Reviewers' comments:

The manuscript "NeuroExaminer: an all-glass microfluidic device for whole brain in vivo imaging" by Dr. Mattern et al is describing all-glass device (NeuroExaminer) that is compatible with whole brain in vivo imaging using light-sheet microscopy. Impressive data has been presented in the manuscript and in the supplementary.

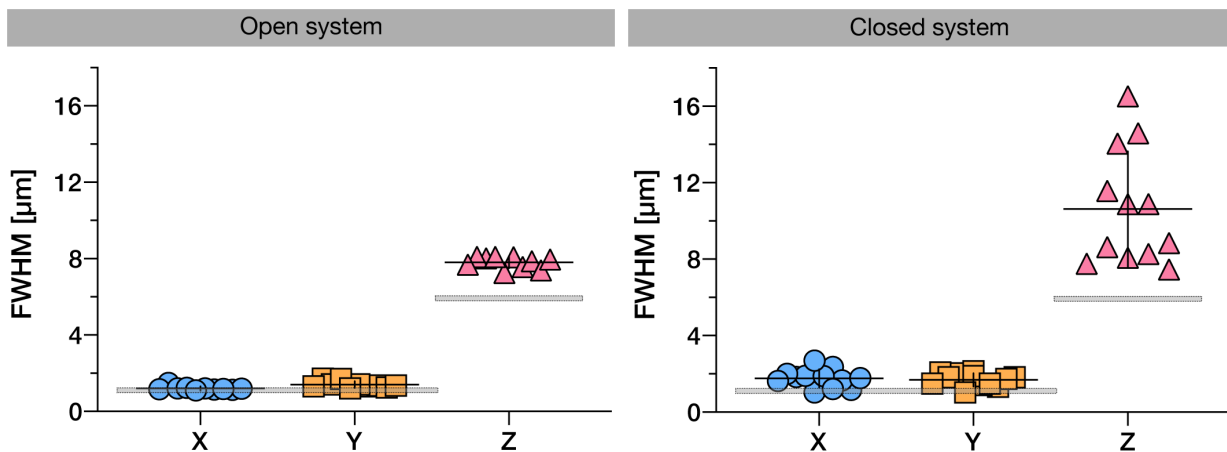
Reviewer #2: I suggest to quantify the resolution offered by the microscope in combination with the microfluidic device by providing PSF measurements (xyz profiles) of beads (for example in agarose) placed inside the imaging compartment in the open and closed configuration.

Response of the authors: We used 200 nm fluorescent microspheres (Dragon Green (FSDG002; 480 nm (excitation maxima), 520 nm (emission maxima), Bangs Laboratories, Fishers, IN, USA) in agarose (diluted 1:10⁶ from the originally supplied solution) and the methodology described in Cole et al *Nature Protocols* 6, 1929-1941 (2011) to determine the point spread function (PSF) in the open and closed configuration of the NeuroExaminer (Figure 1). In order to visualize the beads, we had to increase the laser power and use a longer exposure time (100 ms versus 20 ms) than what we normally use for calcium imaging; all other values (2x2 binning and “extended” light sheet) were kept identical. When imaged, the beads appeared with an elliptical shape in the xy plane in both the open and the closed system.

In the open system (n=10 beads), we obtained full width at half maximum (FWHM) values of 1.20 ± 0.11 , 1.40 ± 0.17 , and 7.80 ± 0.31 for x, y, and z, respectively (Figure 1, left). In the closed system (n=12 beads), we obtained FWHM values of 1.76 ± 0.48 , 1.69 ± 0.34 , and 10.63 ± 3.02 for x, y, and z, respectively (Figure 1, right). Whereas the FWHM values for x and y are similar in the open and the closed configuration of the microfluidic device, the increase in z in both the mean and the standard variation in the closed configuration appears to corroborate our previous findings during calcium imaging that optical

planes in deeper brain layers (more ventral) are generally less well resolved than those in more superficial layers (more dorsal) in the closed compared to the open system. The experimentally obtained values are within the range of the theoretically calculated for x and y (theoretical value: $1.1 \mu\text{m}$) and slightly higher for z (theoretical value: $5.9 \mu\text{m}$).
